EPRI Reviewer (Jon Stewart)  
Comments on the  
Coherency Function

## NRC RAIs for Coherency Model

## Task G1.2 CAV Model

# EPRI Reviewer (Gail Atkinson) Comments on the CAV Model

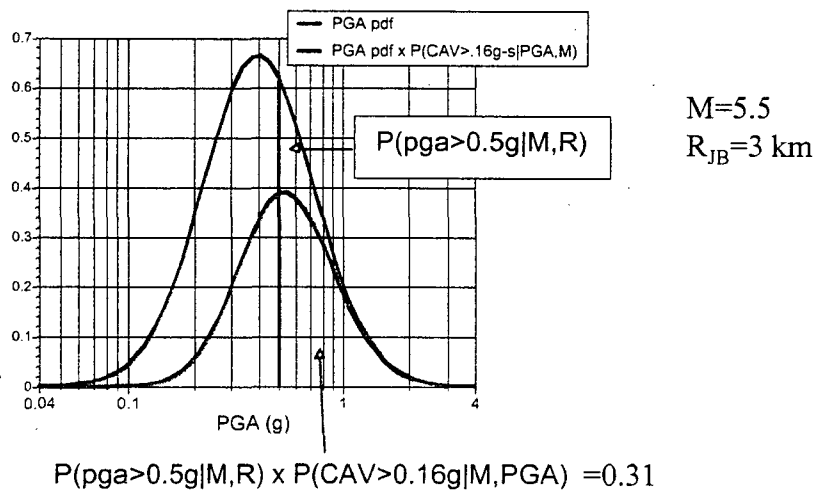
- Why is CAV dependent on Ground motion? Why not develop model for  $CAV(M,R)$  and the just multiply the rate of the event by  $P(CAV > 0.16g-s)$ 
  - This approach is not viable
  - Need the joint probability of  $Sa > z$  and  $CAV > 0.16g-s$  given the earthquake
    - $P(x,y) = P(x)P(y|x)$
    - Since CAV is correlated to the ground motion, must include the ground motion dependence in CAV
    - Ignoring the dependence would under-estimate the hazard

## Residuals Including New EUS Data

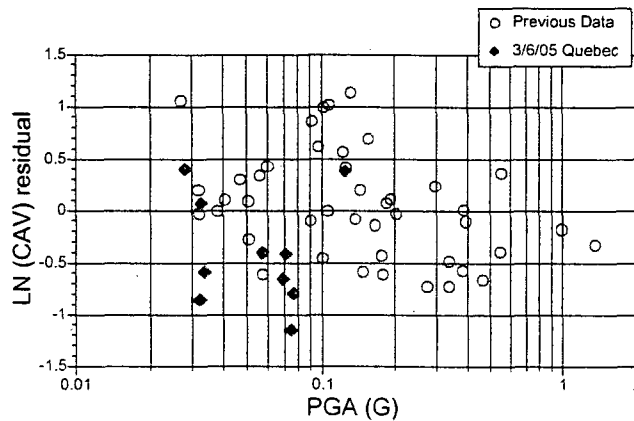
- Trend in EUS residuals vs PGA suggests that WUS model may not be applicable to EUS

WUS model is  
Conservative  
for  $PGA > 0.2g$

Mean = -0.03

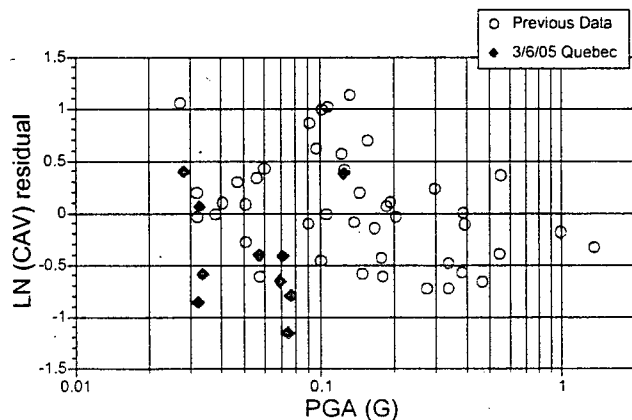
- 3a. The residuals are the estimates of experimental error.
  - The residuals are not experimental error. They represent the variability of CAV that results when a few simplified parameters are used as predictive parameters.
- 3b. How are the CAV distributions with respect to uniform durations and PGAs for the CEUS?
  - Not clear of the question. Residuals shown for EUS CAV as function of duration and PGA
